**WHATCOM COUNTY  
PUBLIC WORKS DEPARTMENT**

**Notice of Quiet Zone Establishment  
Whatcom County, Washington-  
Proposed Quiet Zone at Public Highway/Rail Grade Crossing  
Cove Road DOT #084795Y M.P. 87.655**

**Re: THR-1320003 (U.S. Department of Transportation National Highway-Rail Grade  
Crossing Inventory Number 084795Y)**

**Re: TR-180234 – Notice of Intent to Establish a Railroad Quiet Zone at Cove Road  
(USDOT #084795Y)**

2 REFLECTIVE TRAFFIC CHANNELIZATION DEVICE DETAIL  
NOT TO SCALE

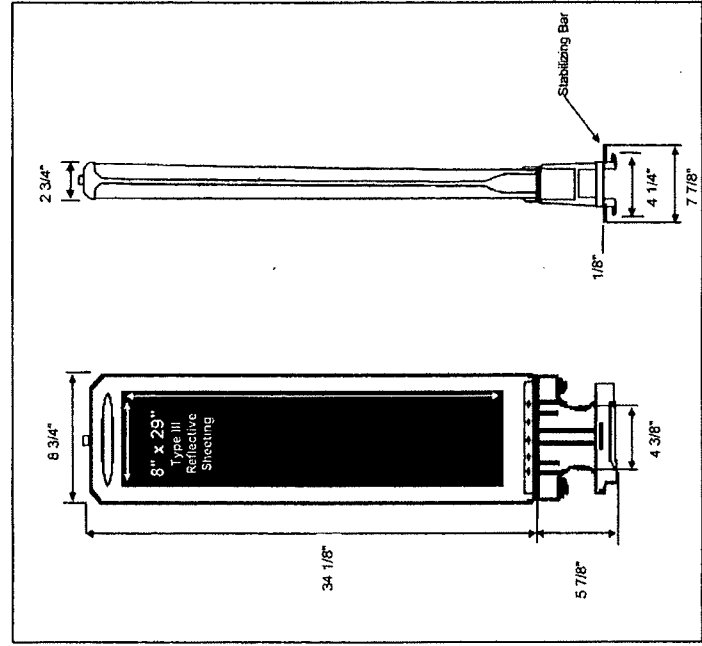
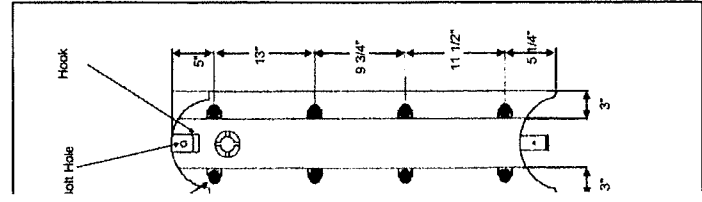
INSTALL APPROXIMATELY 33 FEET OF EDGE STRIPE

INSTALL APPROXIMATELY 12 FEET OF PRECAST WHEEL STOPS, AS DIRECTED BY ENGINEER

BEGIN REMOVAL OF APPROXIMATELY 35 FEET OF EDGE STRIPING STARTING RAILROAD CROSSING DECK AND HEADING NORTHERLY

INSTALL QWIK KURB MODEL L-60 OR APPROVED EQUIVALENT PER THE MANUFACTURER'S RECOMMENDATION. (SEE DETAIL THIS SHEET)

INSTALL QWIK KURB MODEL L-104 REFLECTIVE TRAFFIC CHANNELIZATION DEVICES PER THE MANUFACTURER'S RECOMMENDATION (SEE DETAIL THIS SHEET)
